Change Notice

FT Series

Change to Digital Touch Screen ITO Film

FTAS225-57AN
Digital Touch Screen

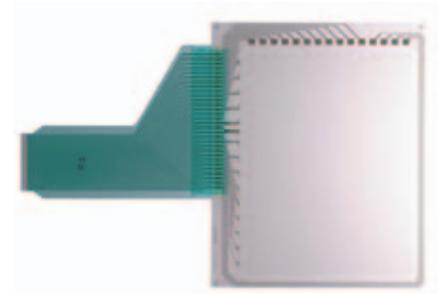
The FT Series will have a change to the ITO film on the Digital Touch Screen. The change will effect both standard and custom models. The ITO film changes are outlined below.

Changes to ITO Film on Digital Touch Screens	
Before Change	After Change
Surface Hardness: 2H (JIS K 5600)	Surface Hardness: 3H (JIS K 5400)
Thickness: 188 μ m	Thickness: 175μm
Anti-Newton ring process: yes	Anti-Newton ring process: no

- Changes to FTAS225-57AN will not effect the touch screen's expected operational life.
- The modifications will not effect any other specifications or dimensions.
- Contact factory if more details are needed.

Changes to ITO film on the Digital Touch Screen will be effective April 2016.
